Sullivan County ESP Installation Bid

Addendum I

Addendum I, includes the following changes which by listing here are made to Attachment B, Statement of Work; Appendix B, Informational Drawings; Mechanical Layout

Mechanical Layout

- M-1 Mechanical Layout, Addendum I Rev 5/14/18
- ESP Manufacturer Assembly Drawings

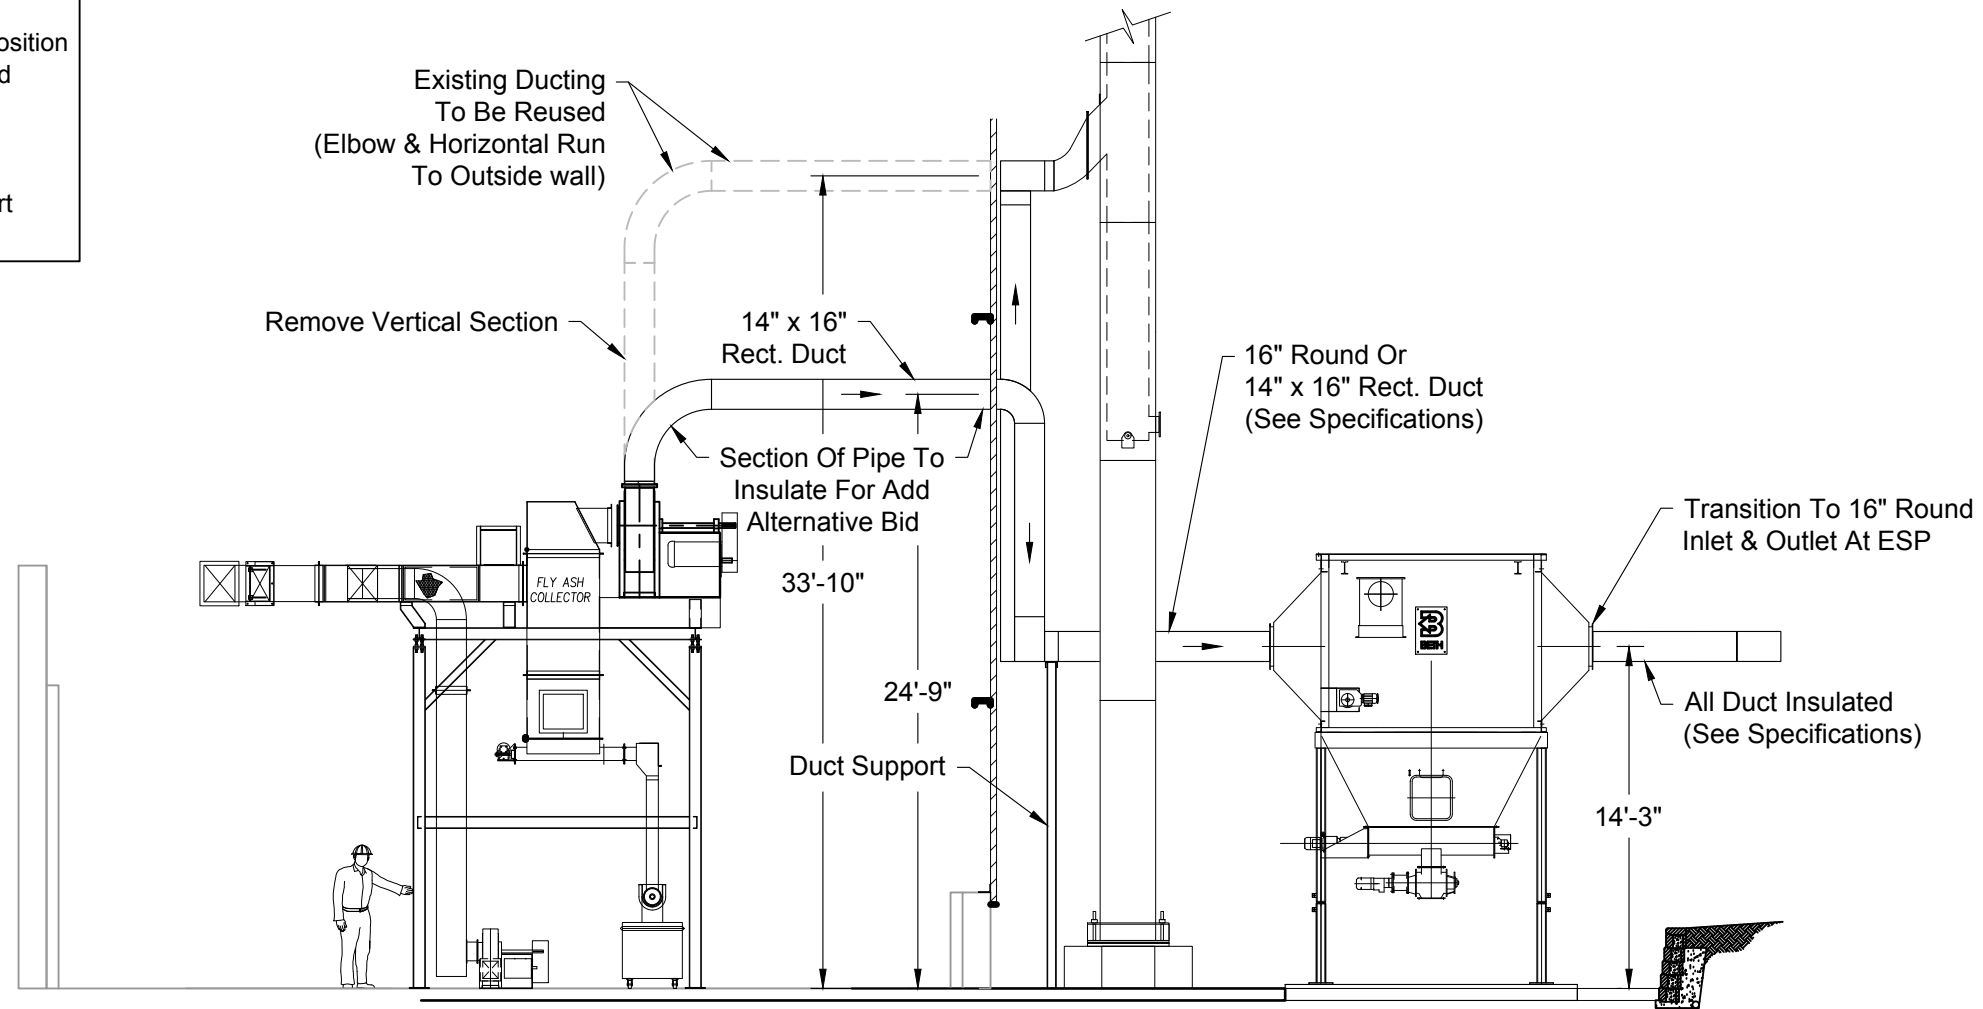
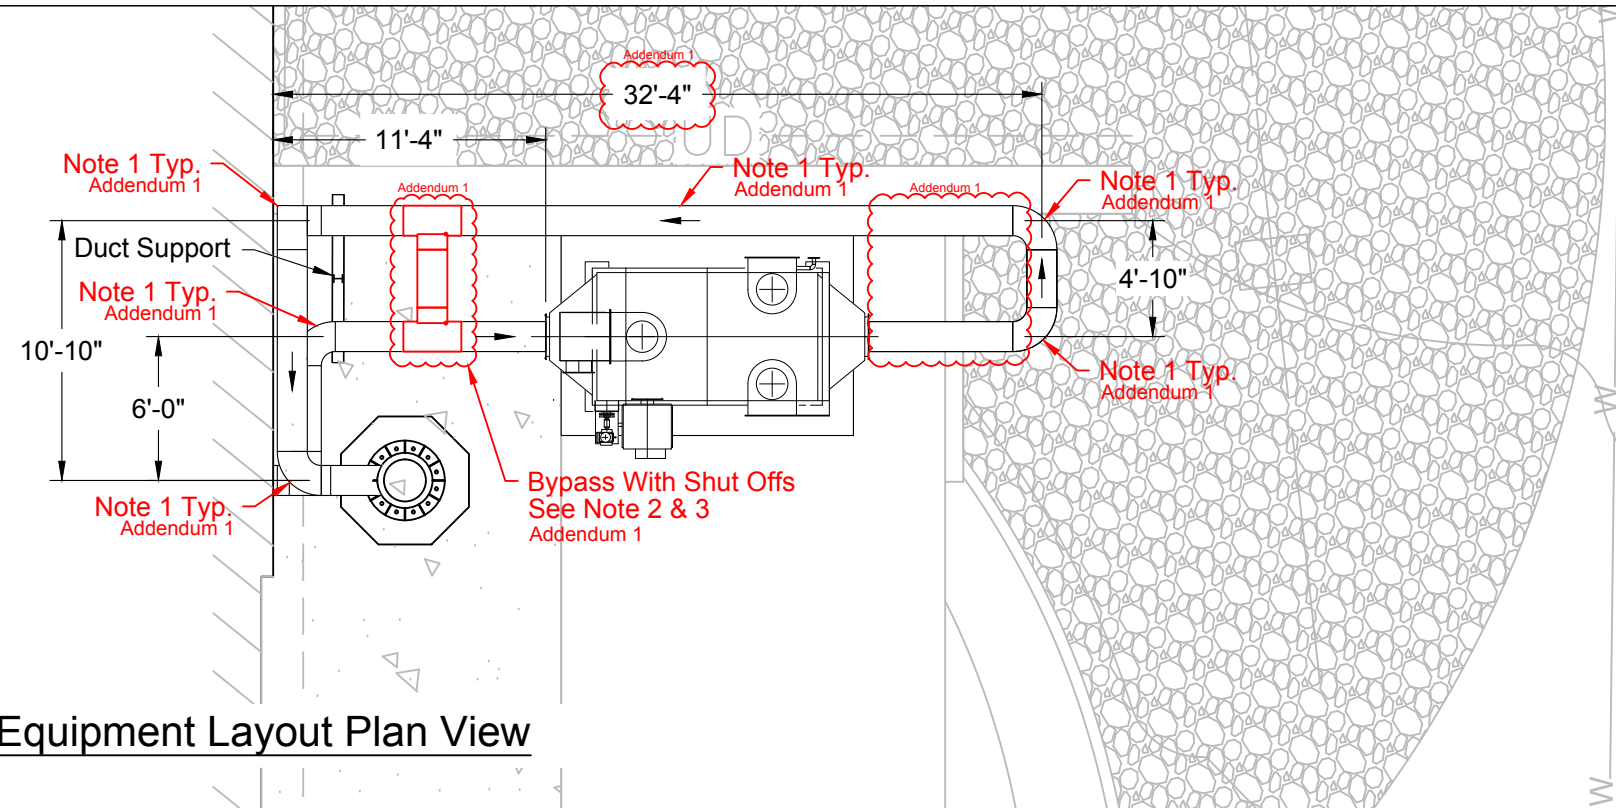
1. Provides for longer straight run of flue duct at exhaust gas exit of ESP
2. Specifies that cleanouts be provided at elbows and center of straight runs longer than 12' in new flue duct
3. Installs a connecting duct and shutoffs to allow operation with the ESP engaged or bypassed

- Notes:
1. Provide clean out at elbows and at center of straight runs greater than 12 feet on new flue duct.
 2. Bypass duct to be the same size as main duct.
 3. Bypass to allow operation of boiler with the ESP offline.
